Item Name: Crosstube Fwd

Reference: rework DSI 9628

DRAWING NO. D407-667-145	TITLE CROSSTUBE ASS'Y (407 HIGH FWD)	REV. C	<b>DART AEROSPACE LTD ENGINEERING ORDER</b>		D.E.O. NO. D407-667-145-C-1	SHEET NO. SHEET 1 OF 1	SCALE NTS
DRAWN <i>q2</i>	CHECKED <i>ASS</i>	MFG. APPR. <i>IB</i>	APPROVED <i>WD</i>		DE APPR. <i>#1</i>		
DATE 11.07.15	DATE 11.07.22	DATE 11.07.22	DATE 11/07/22		DATE 11.07.21

DRAWING NO. D407-667-145	TITLE CROSSTUBE ASS'Y (407 HIGH FWD)	REV. C	DART AEROSPACE LTD ENGINEERING ORDER		D.E.O. NO. D407-667-145-C-2	SHEET NO. SHEET 1 OF 1	SCALE NTS
DRAWN AJS	CHECKED	MFG. APPR.	APPROVED		DE APPR.		
DATE 12.08.02	DATE 12.08.02	DATE 12.08.02	DATE 12.08.02		DATE 12.08.02

## DART SERVICE INSTRUCTION

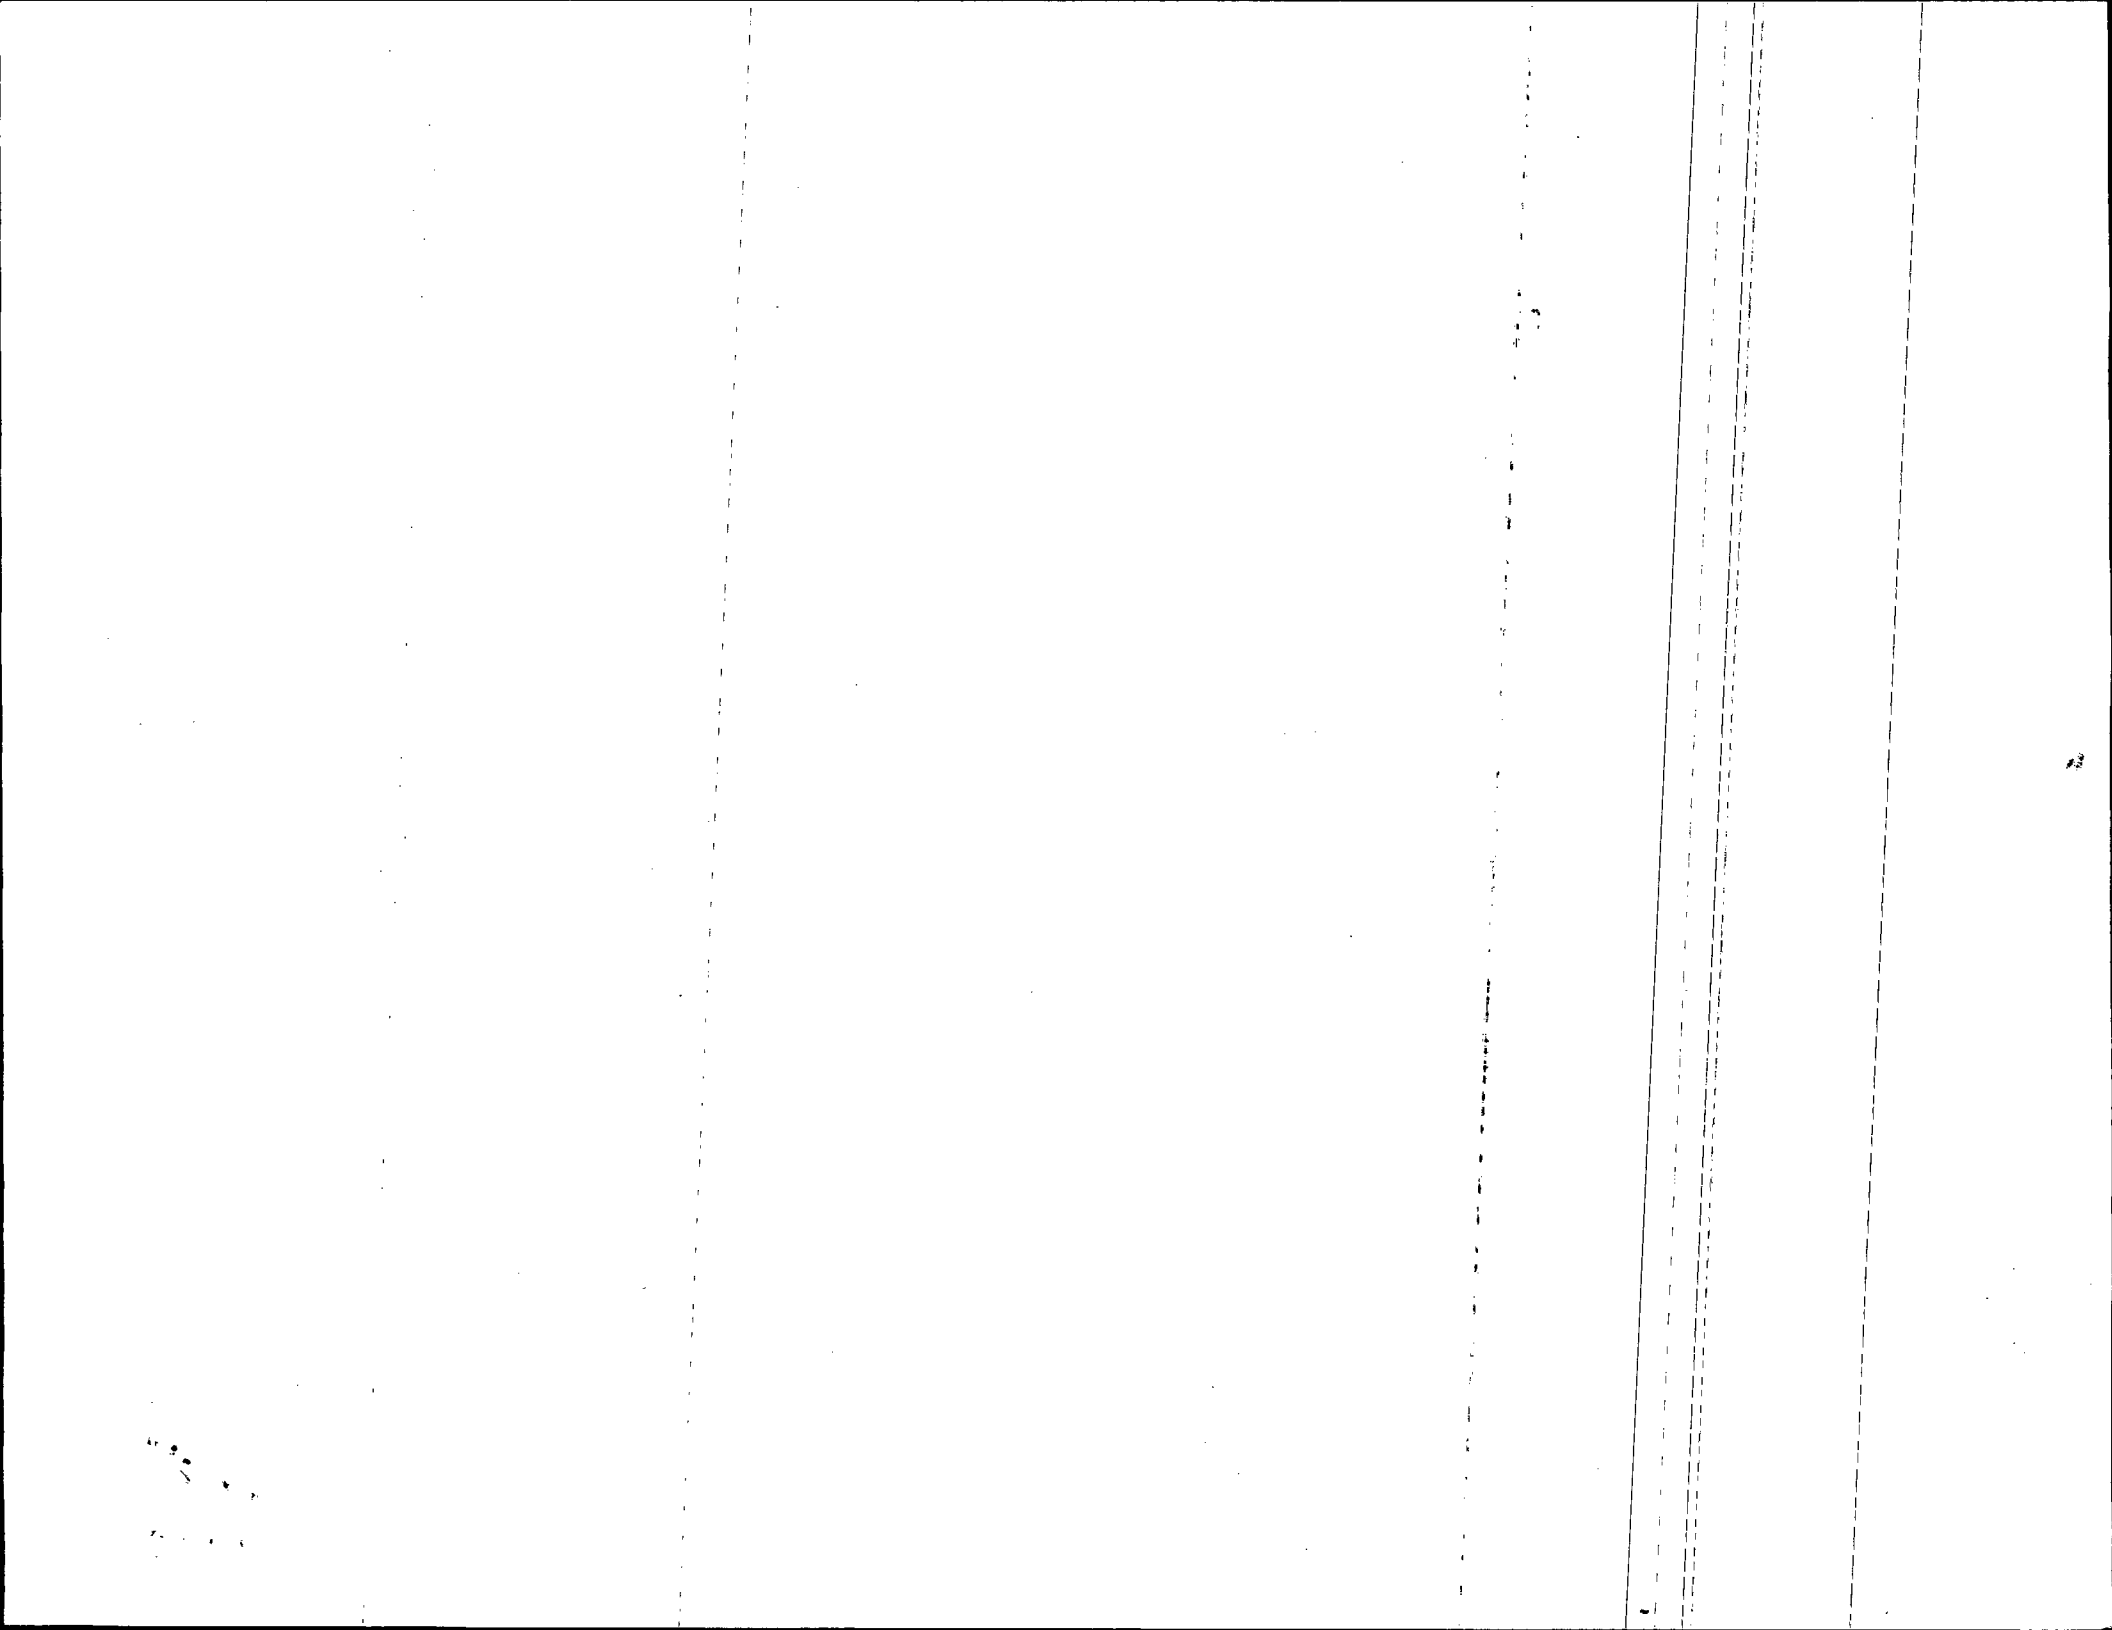
### PURPOSE:

The purpose of this service instruction is to permanently add the D206-667-017 Kit to the DXXX-667-101/-103/-105/-107 Crosstube kits.

DXXX-667-101/-103/-105/-107 Crosstubes at CHG 005/006/005/003 (respectively) and later are supplied with the D206-667-017 Grounding Strap Kit installed per section 3.2 of IIN-D206-667 Rev. D.

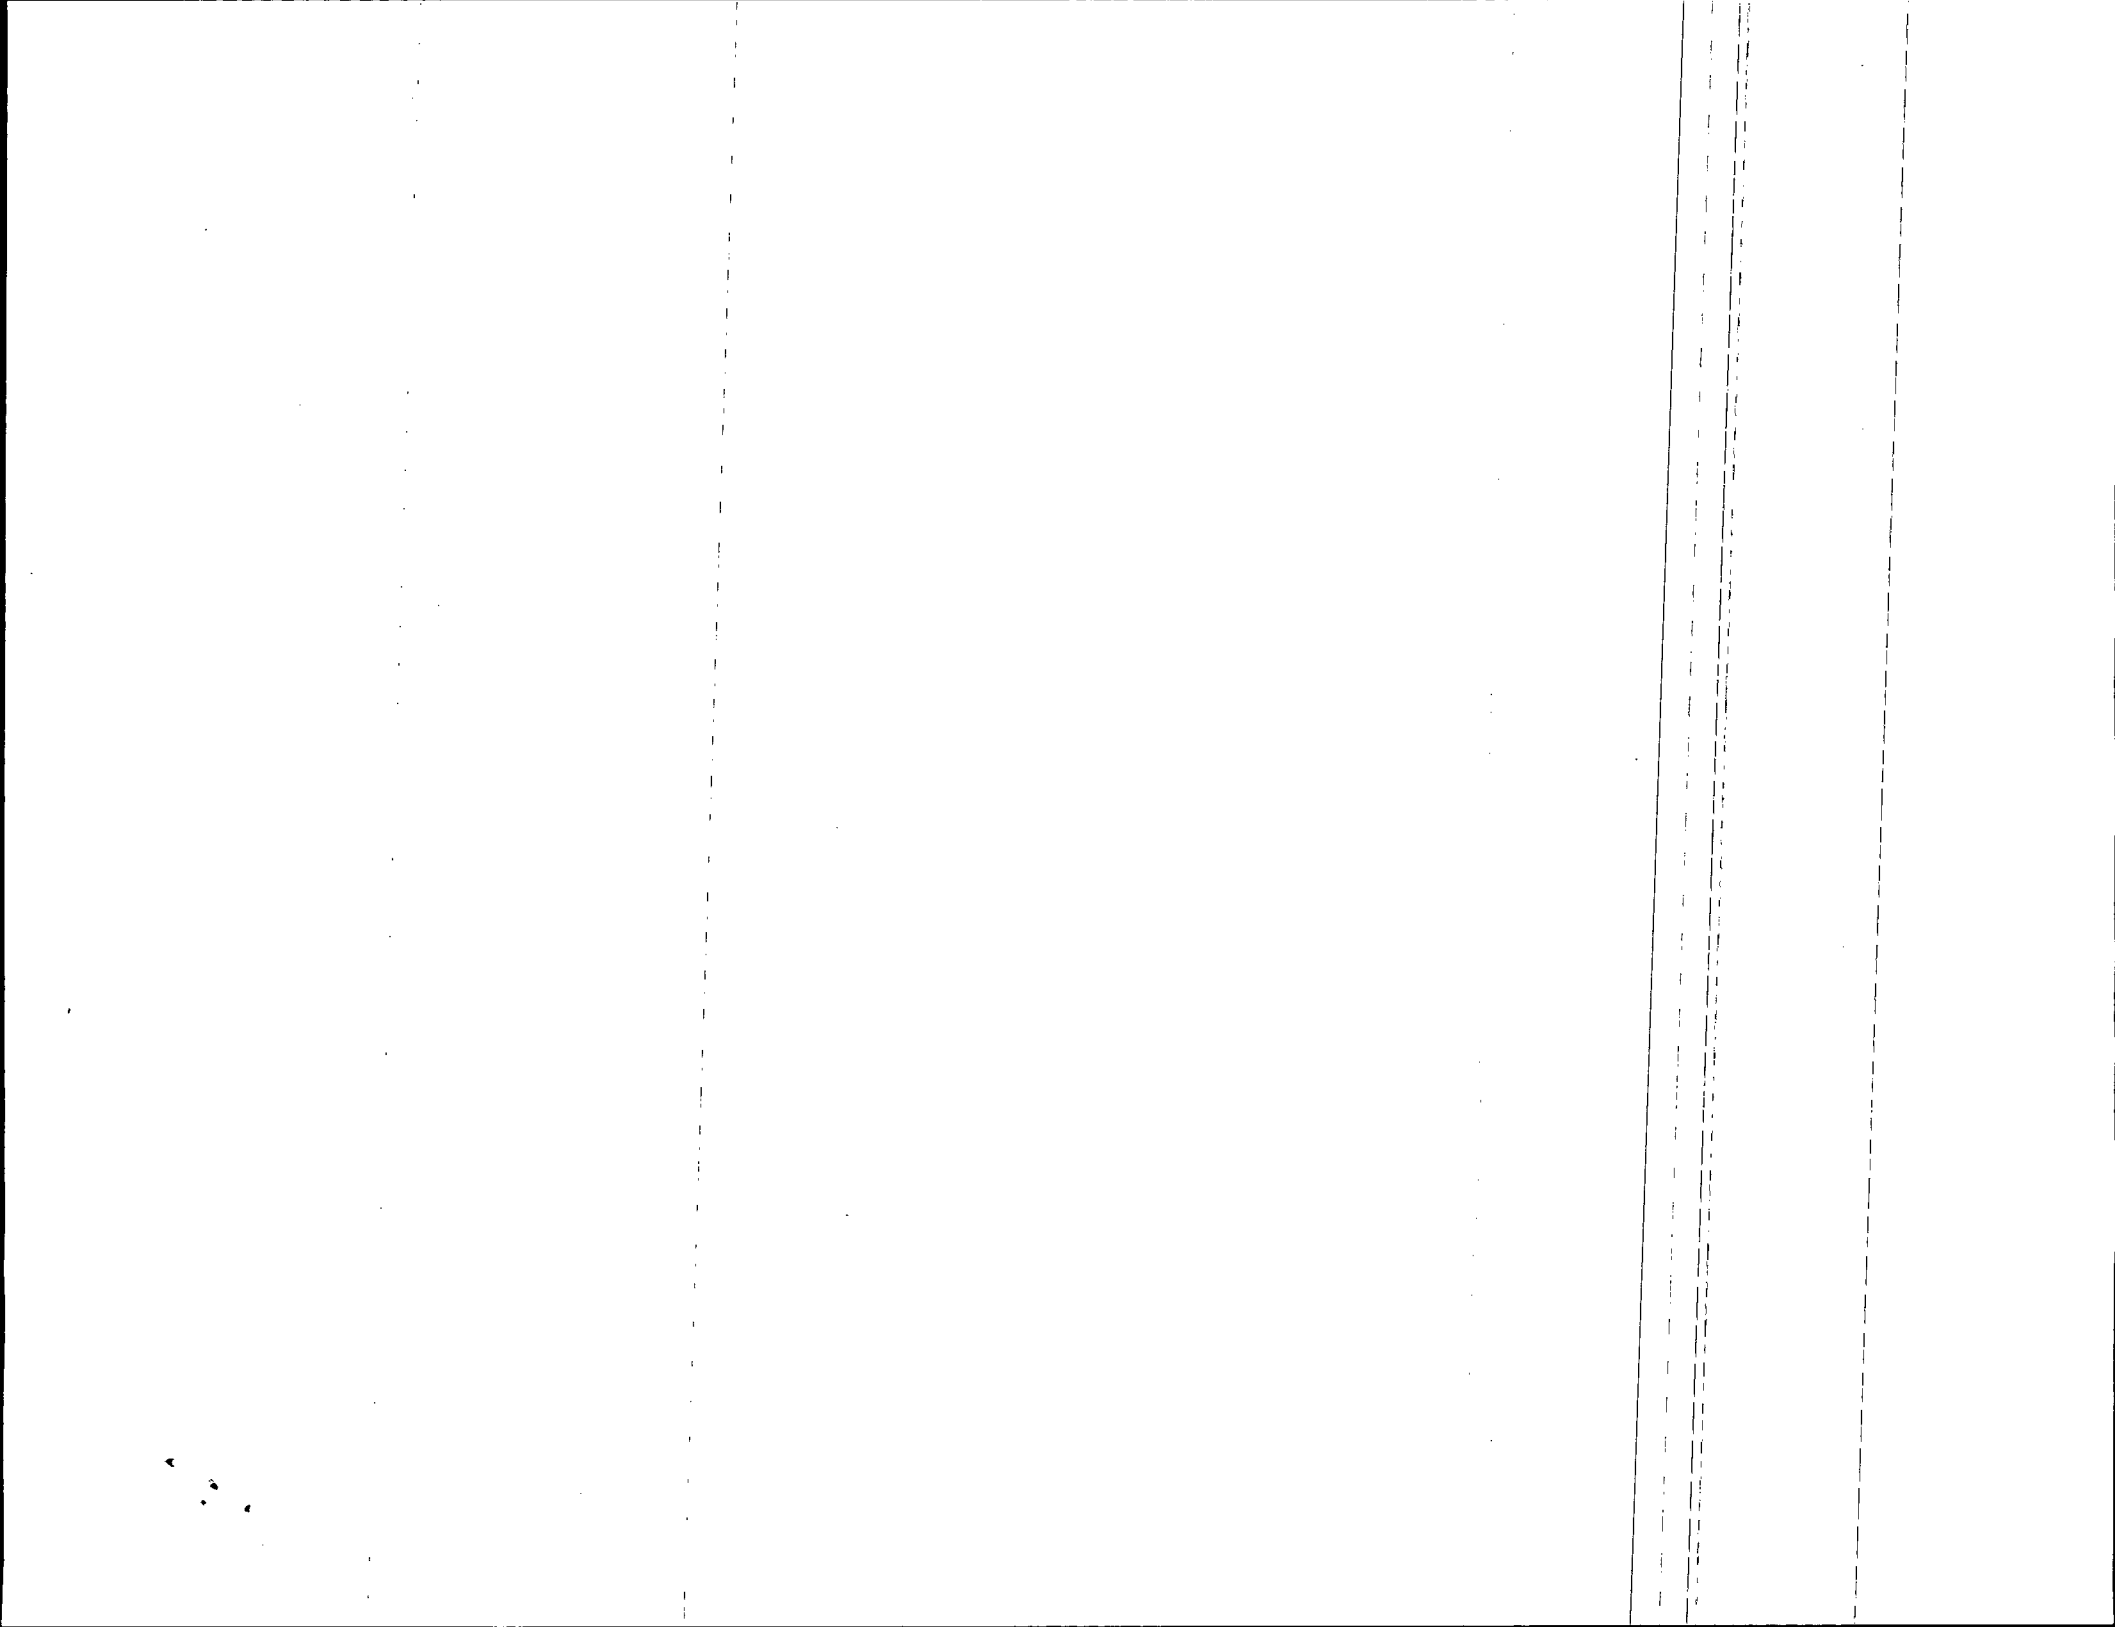
**PURPOSE:**

REPLACE MAGNOBOND WITH PROSEAL.

**IS:**

Item	Qty -145	Part Number	Description
9	A/R	PROSEAL 890 B-2	SEALANT, AMS-S-8802 CLASS B-2

**WAS:**

9	A/R	MAGNOBOND 6398	ROCKWELL SPECIFICATION RBO-120-023 ADHESIVE (TEXTRON/BELL SPEC. 299-947-100, TYPE II, CLASS 2 ADHESIVE)
---	-----	----------------	---

NOTE 12 & 15, SHEET 1 IS AMENDED AS FOLLOWS:

**IS:**

- 12) TO INSTALL D2891-1 SUPPORT: ABRASE MATING SURFACE OF SUPPORT AND CROSSTUBE WITH 180-GRIT SANDPAPER AND REMOVE RESIDUE WITH MEK (OR EQUIVALENT). APPLY A 0.04" TO 0.07" THICK LAYER OF PROSEAL 890 CLASS B-2 (OR AMS-S-8802 CLASS B-2) SEALANT TO MATING SURFACE OF SUPPORT.
- 15) TORQUE CLAMPS 80 TO 100 IN-LB. ENSURE AT LEAST 1.5 THREADS SHOWING IN SAFETY AND THAT NUT HAS NOT BOTTOMED-OUT AFTER TORQUING. **PRIOR TO PACKAGING, RE-CHECK TORQUE ON CLAMPS AFTER PROSEAL 890 SEALANT HAS CURED FOR 72 HOURS.**

**WAS:**

- 12) INSTALL D2891-1 SUPPORT USING 0.03" TO 0.06" THICK LAYER OF MAGNOBOND 6398 PER QSI 015. LET CURE FOR 12 HOURS AFTER INSTALLATION AND PRIOR TO PACKAGING.
- 15) TORQUE CLAMPS 80 TO 100 IN-LB. ENSURE AT LEAST 1.5 THREADS SHOWING IN SAFETY AND THAT NUT HAS NOT BOTTOMED-OUT AFTER TORQUING.

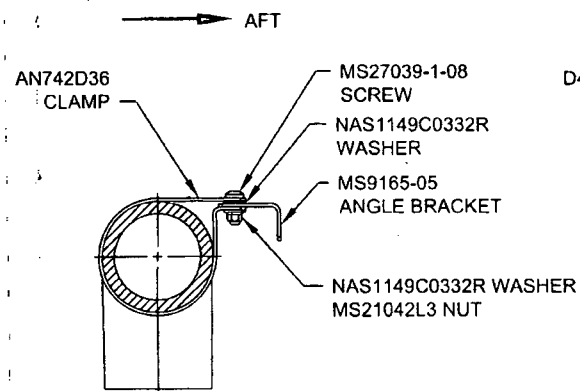
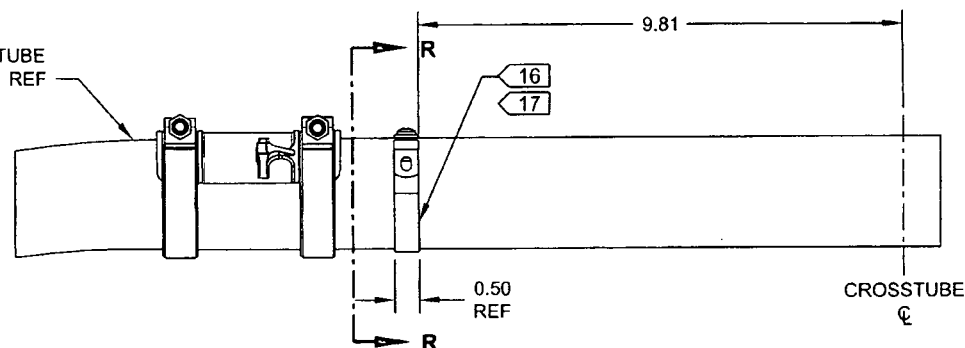
**PURPOSE:**

ADD ELECTRICAL GROUNDING STRAP

ITEM	QTY -145	PART NUMBER	DESCRIPTION
1	X	D407-667-145	CROSSTUBE ASSEMBLY (407 HIGH FWD)
10	2	AN742D36	CLAMP
11	2	MS9165-05	ANGLE BRACKET
12	2	MS21042L3	NUT (OR MS21042-3)
13	2	MS27039-1-08	SCREW
14	4	NAS1149C0332R	WASHER (OR AN960C10L)

- 16) MASK AREA UNDER CLAMP PRIOR TO PAINTING
- 17) SEAL EDGES WHERE AN742D36 CLAMP MEETS WITH THE CROSSTUBE USING SIKAFLEX-241/-291 OR MIL-S-8802 CLASS B2 OR PROSEAL 890 SEALANT
- 18) PERFORM RESISTANCE CHECK TO ENSURE MAX RESISTANCE IS 10 MILLIOHMS
